**EPA Superfund  
Record of Decision:**

**ABERDEEN PROVING GROUND (MICHAELSVILLE  
LANDFILL)  
EPA ID: MD3210021355  
OU 03  
ABERDEEN, MD  
07/17/2000**

**WESTERN BOUNDARY STUDY AREA  
OPERABLE UNIT 1 ABERDEEN AREA  
ABERDEEN PROVING GROUND, MARYLAND  
RECORD OF DECISION  
FINAL**

July 2000

**FIGURE 3**

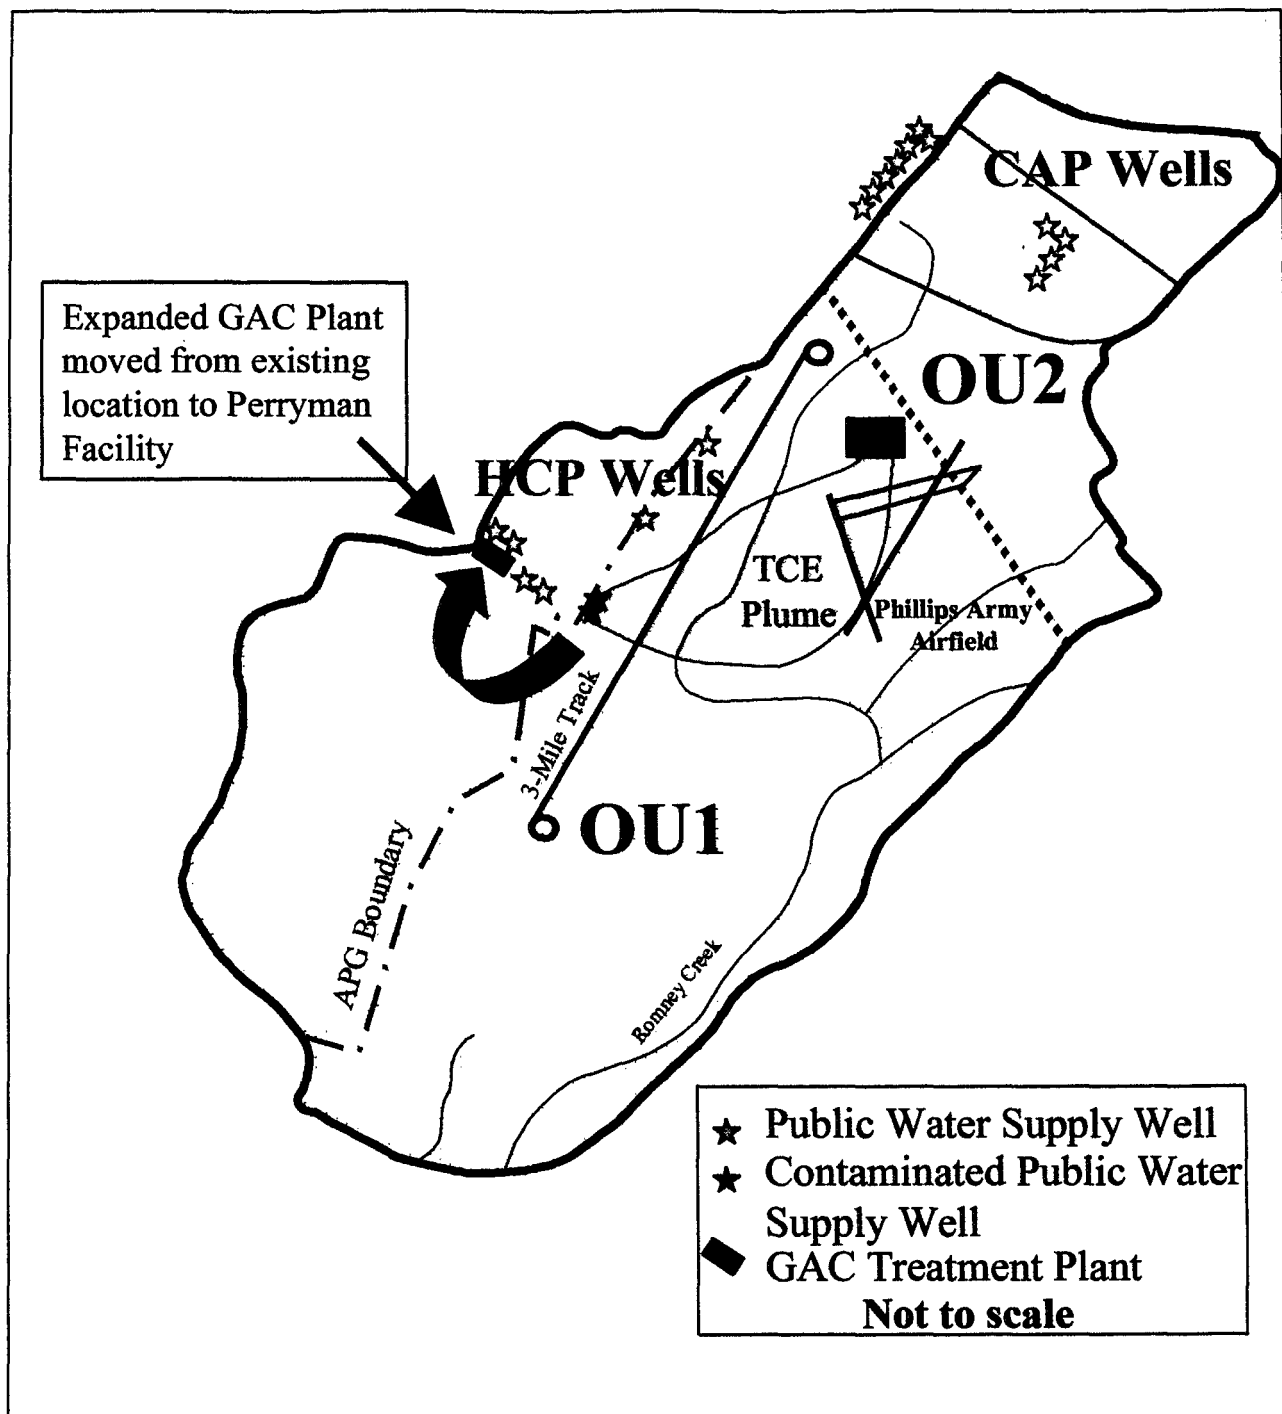
**Comment No. 12:** "It is important to make the graphics support the discussion within the proposed plan. Figure 3 depicts the groundwater plume, which is located on page 3. The problem lies in the fact that the plume and the wells are discussed on pages 6, 7 and 8. As a RAB member, I request that the map be made easier to reference either by including future site specific maps as a box on each relevant page or as a foldout so the reader can reference it regardless of what page the related text is found. This same approach should be taken for acronyms. It is important to make sure that the map is adequately marked for the discussion. For instance, while a majority of the plume discussion revolves around AFTA, this area is not marked on the map. Additionally, it would have been very helpful to have a groundwater contour map to depict what was being said in the text. As we have discussed many times with regard to RAB presentations, there are many ways to make complicated material easier to understand. As a community RAB member, I request that the IRP and its contractors focus on this issue for the next proposed plan."

**Response No. 12:** APG will focus on improving graphics and readability in the next proposed plan.
